# METROPOLITAN GOVERNMENT OF NASHVILLE AND DAVIDSON COUNTY

## STAFF RECOMMENDATION 2224 Blair Boulevard June 20, 2018

**Application:** New construction – addition  
**District:** Hillsboro-West End Neighborhood Conservation Zoning Overlay  
**Council District:** 18  
**Map and Parcel Number:** 10415014400  
**Applicant:** Nick Dryden, DAAD Group  
**Project Lead:** Jenny Warren, jenny.warren@nashville.gov

**Figure 5: Existing garage to be demolished**

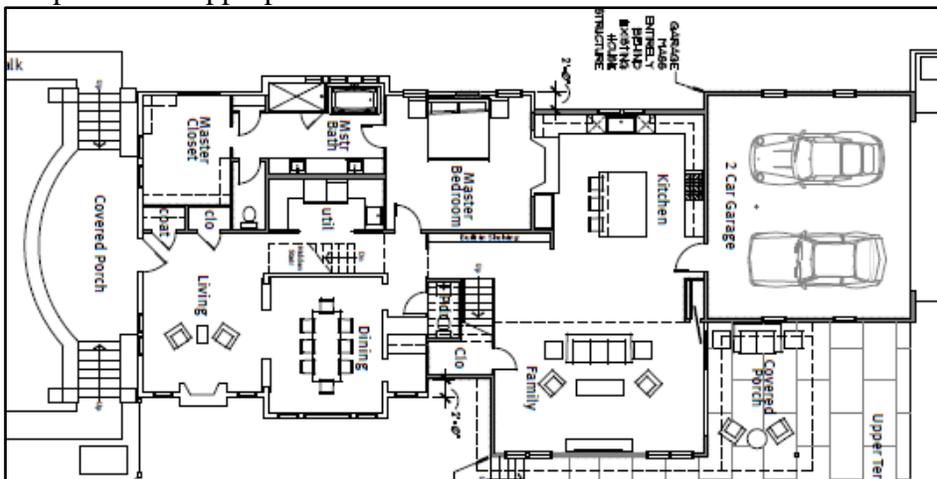
The existing garage is a non-contributing concrete block outbuilding. While a garage does show on the 1932 and 1957 Sanborn maps, it is on the northeast corner and is likely not this same outbuilding. The existing garage likely dates from 1960 or later. Regardless of its age, the outbuilding is not of particular architectural or historic interest and its demolition will not be detrimental to the public interest.

Staff finds that the proposed partial demolition at the rear of the house and complete demolition of the existing garage is appropriate and meets Section III.B.2 for appropriate demolition and does not meet section III.B.1 for inappropriate demolition.

**Figure 9: Proposed west elevation:** Staff finds the wide wall dormer above the garage inappropriate, but the narrow spaced wall dormers in the middle of the house appropriate.

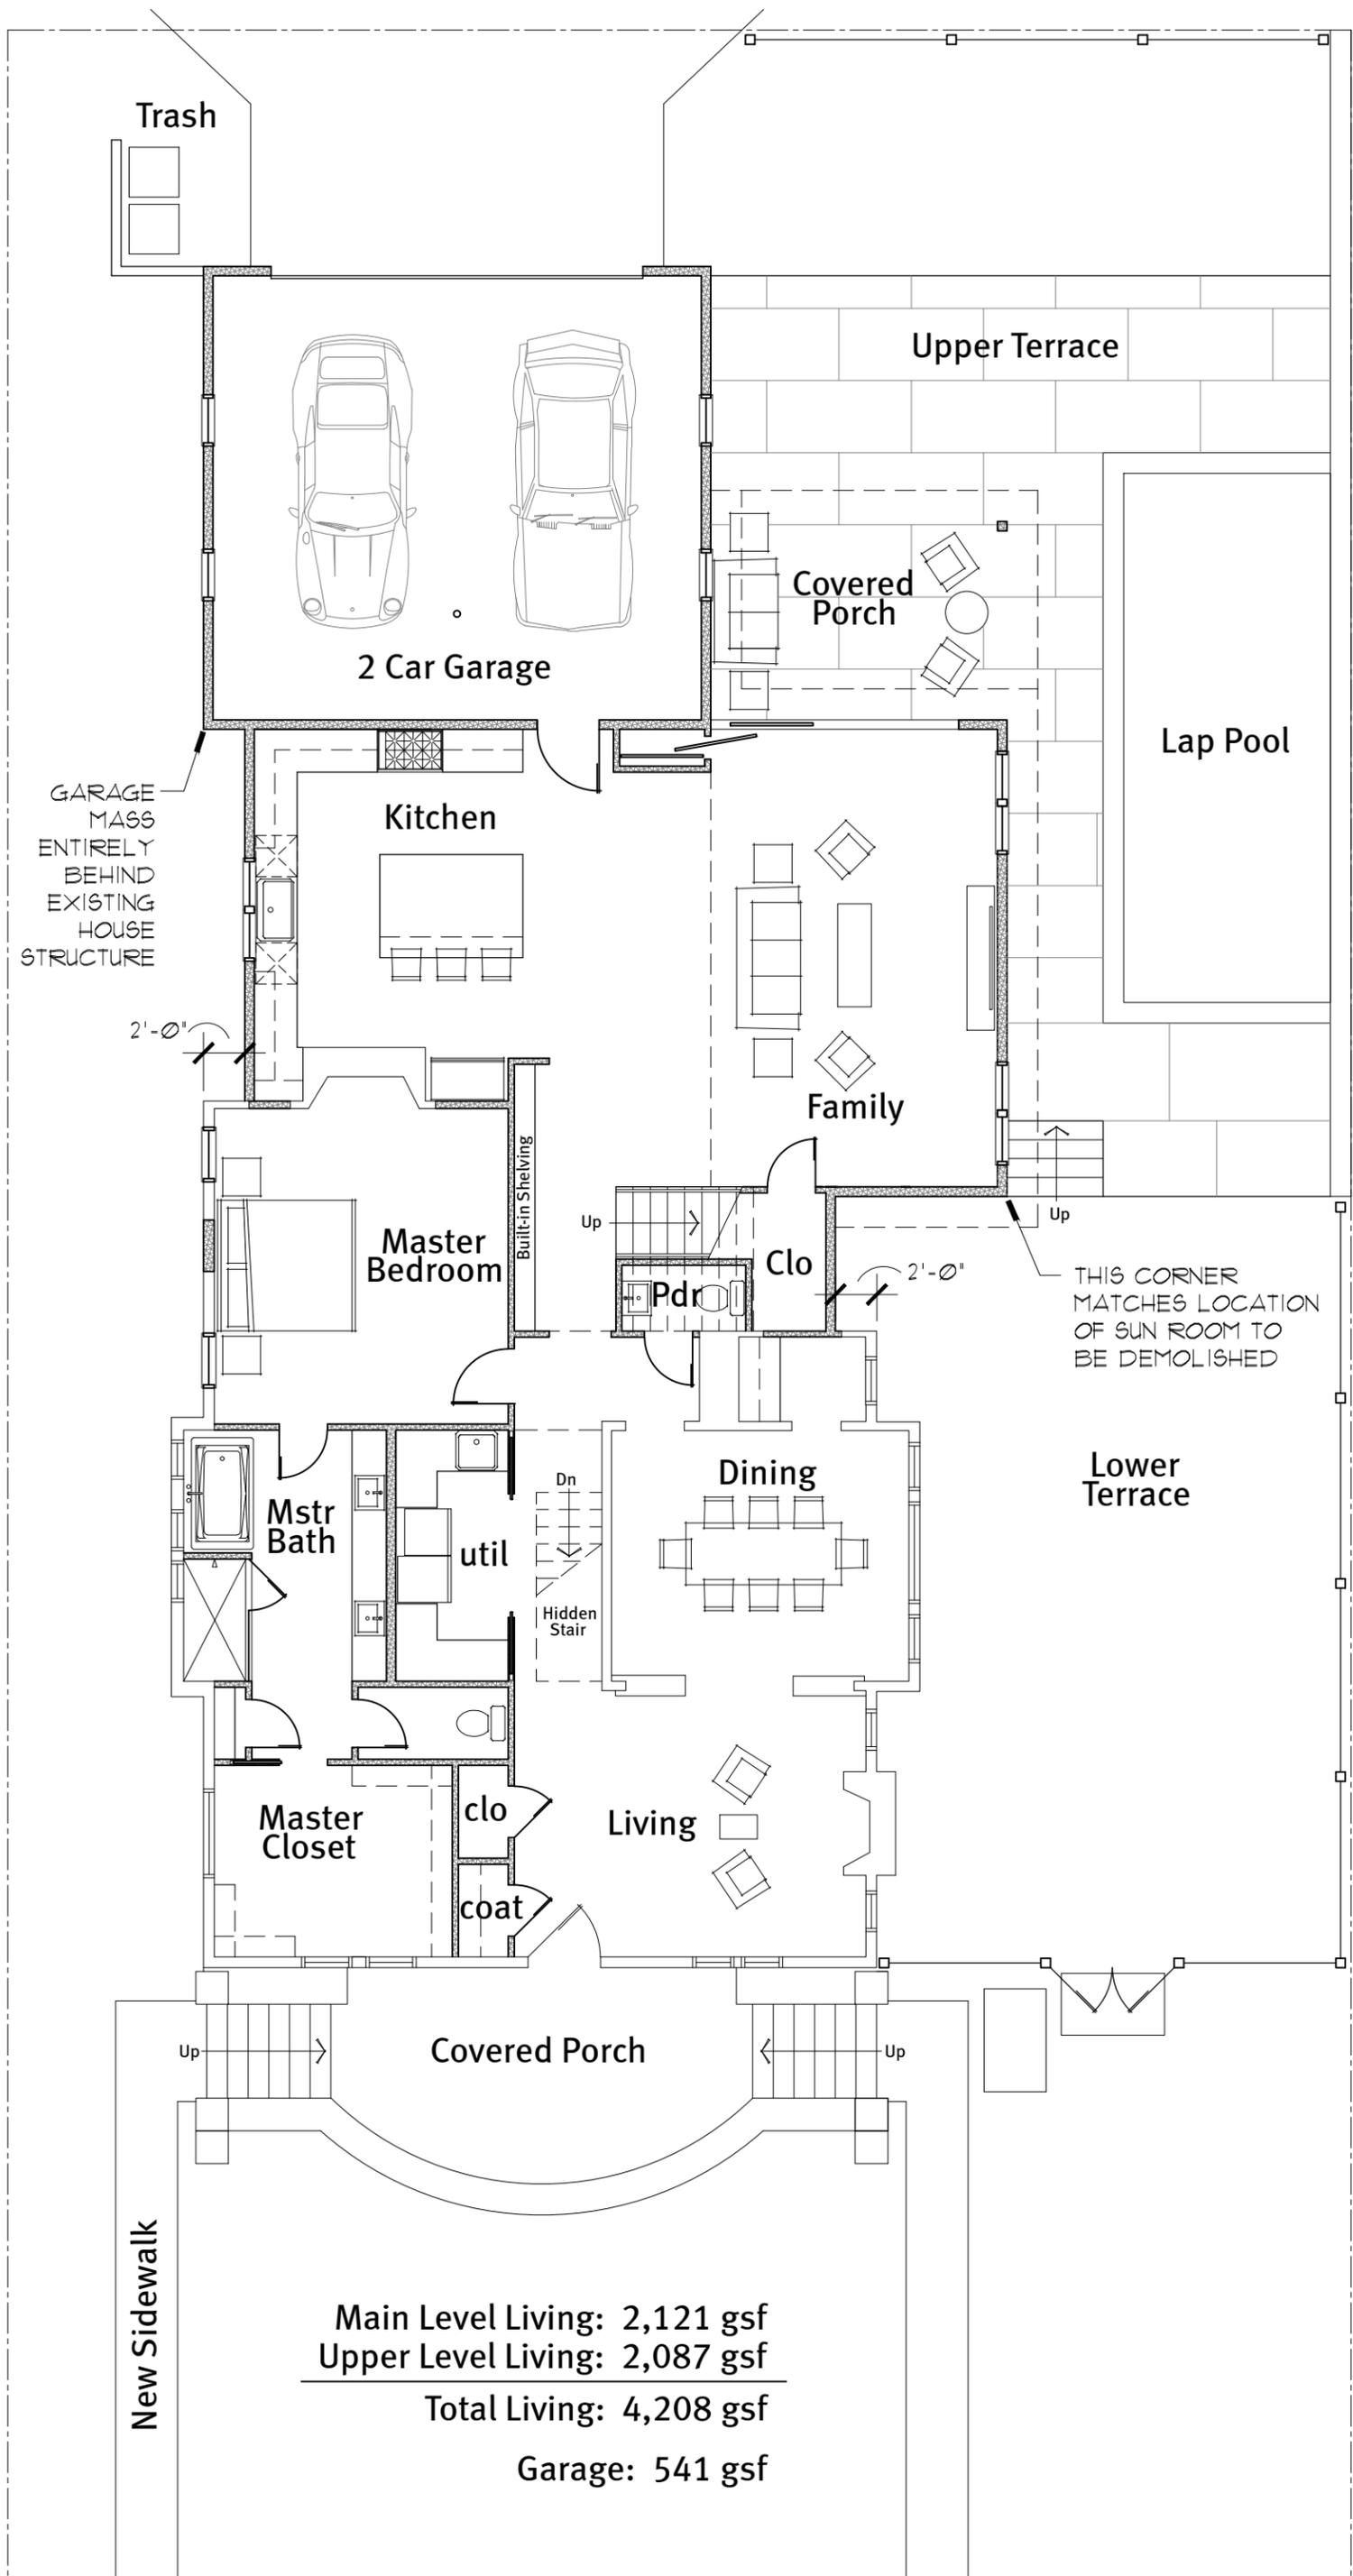
**Roof form:** The primary roof of the addition will be a rear-gable that ties into the roof form of the historic house approximately one foot (1') lower than the existing ridge. This primary rear gable (not including the attached garage portion) will include shed dormers on the east elevation and three narrow wall dormers on the west elevation. The rear portion of the addition, over the attached garage, includes wide wall dormers. The Commission generally does not approve wall dormers as they are rare in the historic context and serve to accentuate height. In this case, Staff finds the narrow dormers in the middle to be appropriate because of their location and narrow width but finds that the wide dormers on the rear are inappropriate.

The side gabled stair tower will have an 8/12 pitch. The shed roof of the rear covered porch and one-story family room will each have a slope of about 3/12. The shallower roof slopes are appropriate because they are located in minimally visible locations and/or are porch roofs, which typically have lower slopes. The attached garage has a rear-facing gable with a pitch of about 8/12 and wide wall dormers on both side elevations. Overall, Staff finds the roofs of the proposed addition to be compatible with the existing building with the exception of the wall dormers on the second floor of the garage. With the removal of the second floor of the garage, Staff finds that the proposal meets section II.B.1.e of the design guidelines for roof form.

1. The second level of the attached garage shall be removed to create a more appropriately massed addition for the historic home;
2. Staff shall approve the following materials, prior to purchase and installation: brick, cladding, roofing material, trim, terrace material, garage door, pedestrian door and windows; and,
3. The HVAC shall be located on the rear elevation, or on a side elevation, beyond the midpoint of the house;

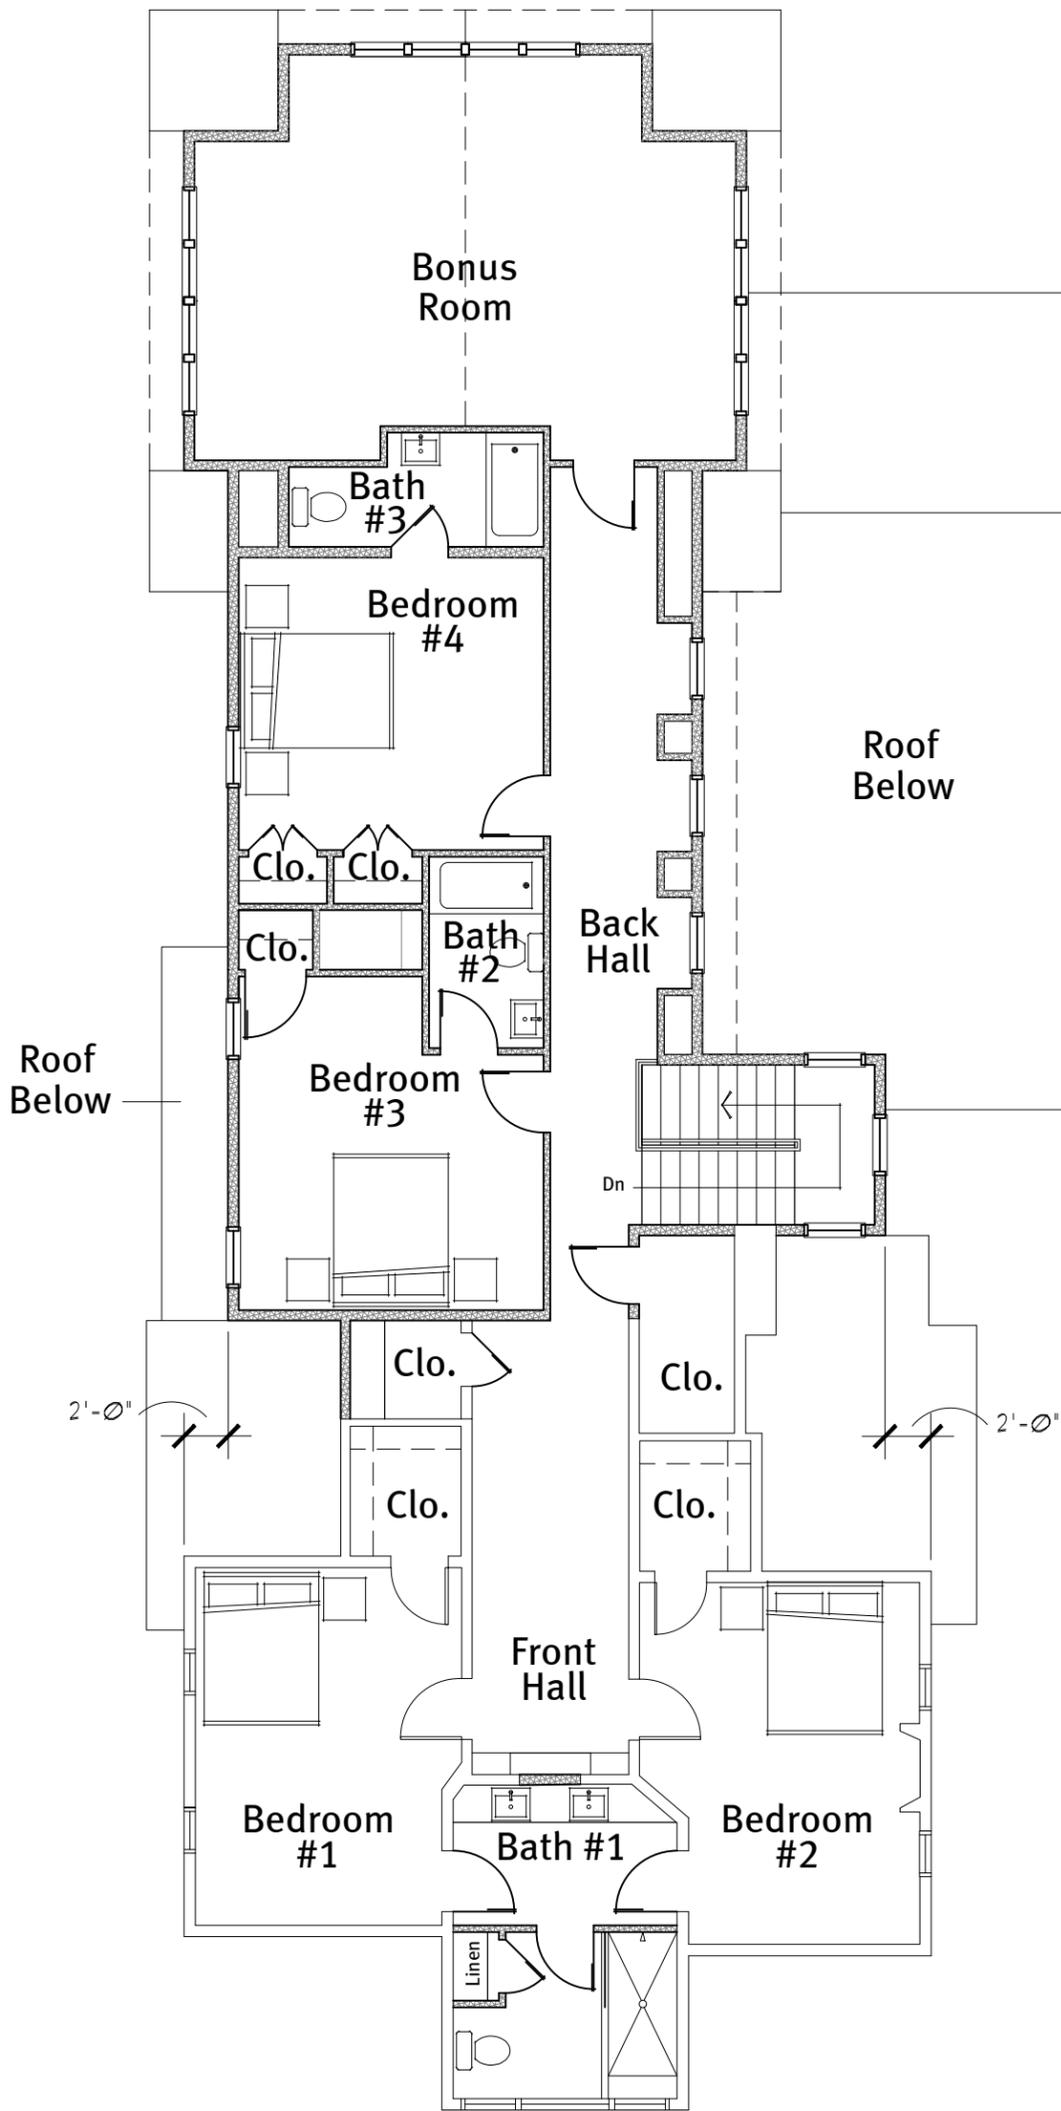
**Proportion and Rhythm of Openings:** The windows on the proposed addition are generally twice as tall as they are wide, thereby meeting the historic proportions of openings. There are no large expanses of wall space without a window or door opening. At this time, there is no plan to replace the existing windows and doors, beyond the changes to the master bedroom windows on the west elevation, as discussed above. Staff finds the project's proportion and rhythm of openings to meet section II.B.1.g of the design guidelines.

**1 East Elevation**

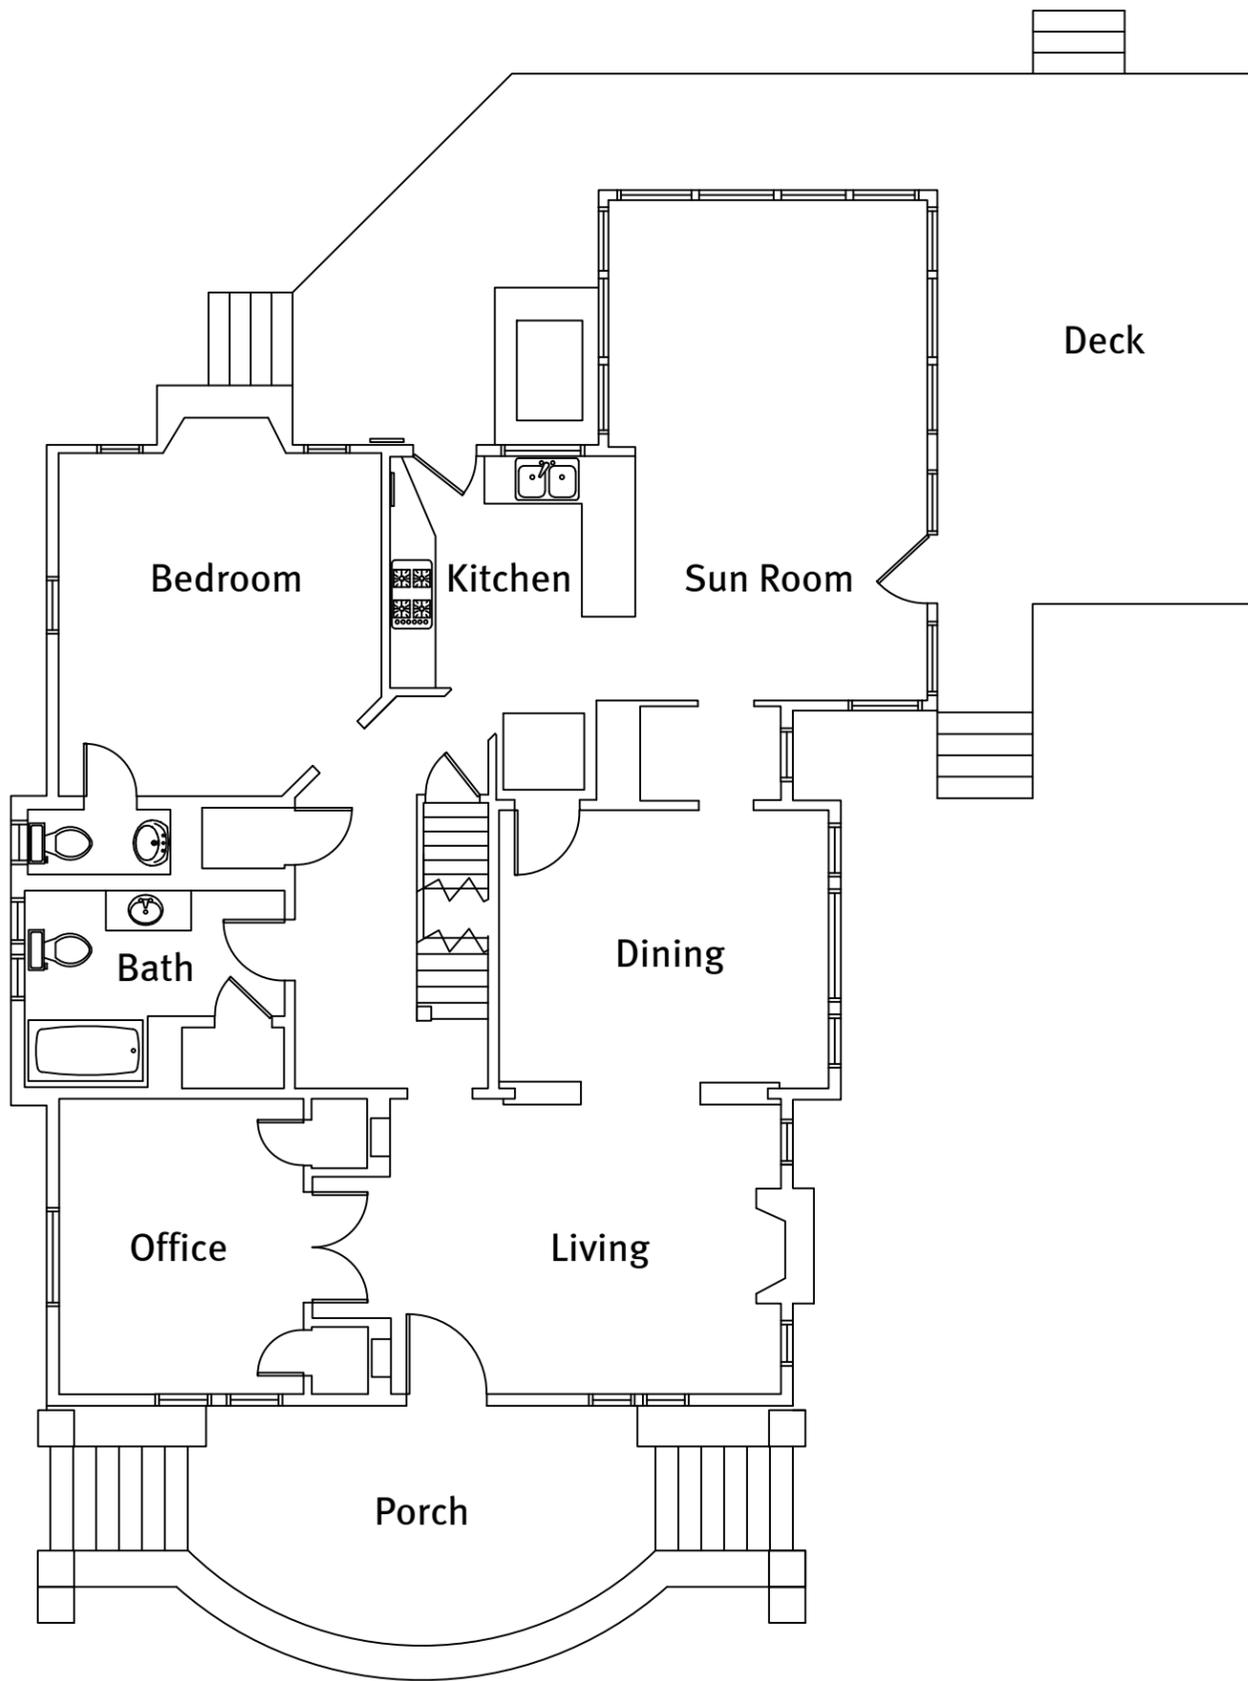
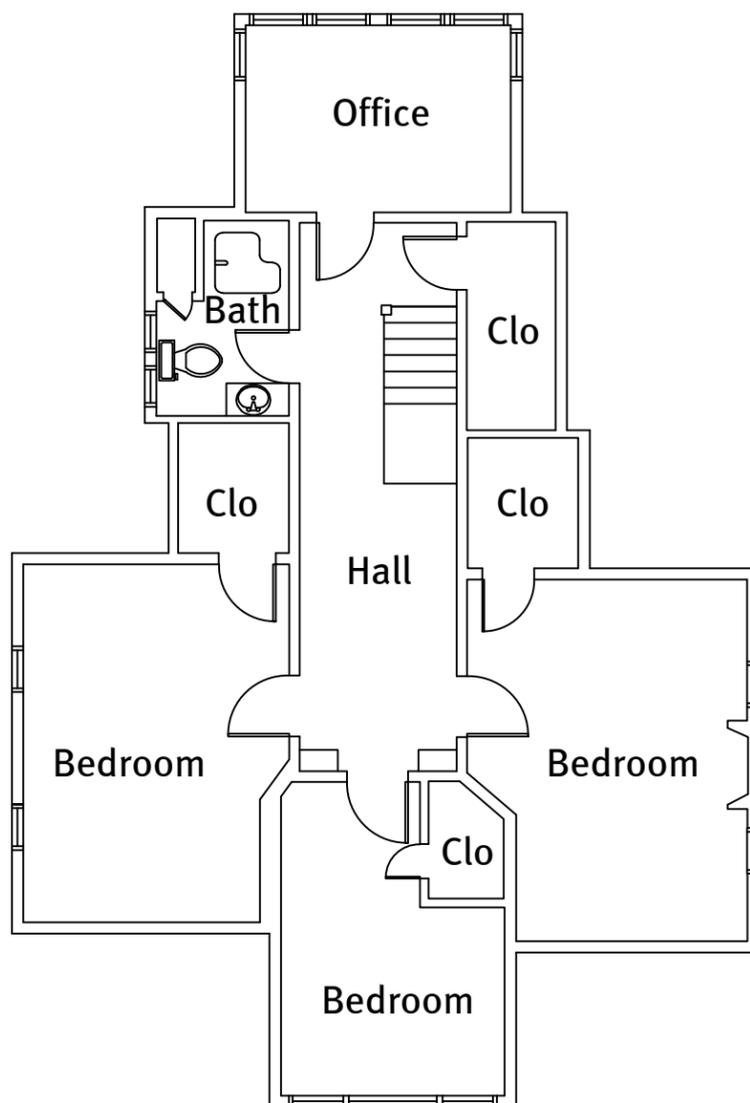
The proposed addition will be no taller than the existing house. The ridge line of the new rear-facing gable will be lower than the original ridge line of the side-facing gable by about one foot (1'). Staff finds the majority of the proposed second story to be

appropriate, with the exception of the addition's height at the rear. The roof height steps up above the garage and wide wall dormers are used on both side elevations, further increasing the perception of height. The eaves on this portion of the addition are approximately thirteen feet six inches (13'6") from finished floor height - significantly higher than the eave heights of the historic house, which are about eight feet nine inches (8'9") from finished floor.

With the condition that the second floor is removed from the attached garage, Staff finds that the height and scale of the proposed addition could be compatible with the historic house and would meet Section II.B.1.a. for height and Section II.B.1.b for scale.
